RE: St. Lucie Unit 2  
Docket No. 50-389  
Proposed License Amendment  
Add COLR Methodology - Improved Heat Flux Correlation

## **ATTACHMENT 1**

St. Lucie Unit 2 Marked-up Technical Specification Pages

FIGURE B 2.1-1  
Axial Power Distributions For Thermal Margin Safety Limits

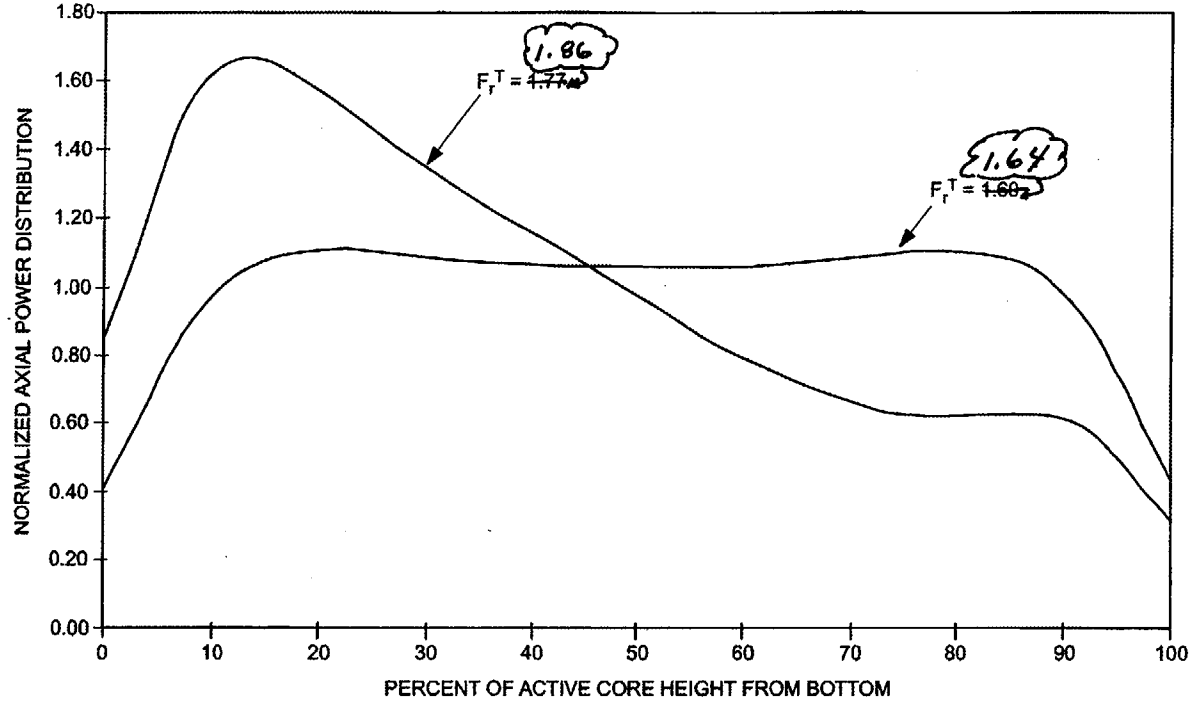
The Bases for TS 2.1.1 are clarified with respect to the application of ABB-NV DNB correlation and the Bases Figure B2.1-1, supporting the curves of thermal margin safety limit lines Figure 2.1-1, is revised to reflect the application of ABB-NV critical heat flux correlation.

The text in the Bases for TS 2.1.1 is modified to reflect the application of ABB-NV DNB correlation. Accordingly, references to CE-1 critical heat flux (CHF) correlation are modified to quote both CE-1 and ABB-NV correlation. Also, the TS Bases Figure 2.1-1 is modified to reflect the implementation of ABB-NV CHF correlation. The use of appropriate NRC approved DNB correlation is stipulated by TS 6.9.1.11. Specific analysis will use the appropriate DNB correlation and the corresponding DNBR limit to ensure that the thermal margin DNBR limit is not violated for the combination of transient conditions initiated within the limiting conditions of operation in combination with the reactor protection systems.

*based on ABB-NV CHF correlation*
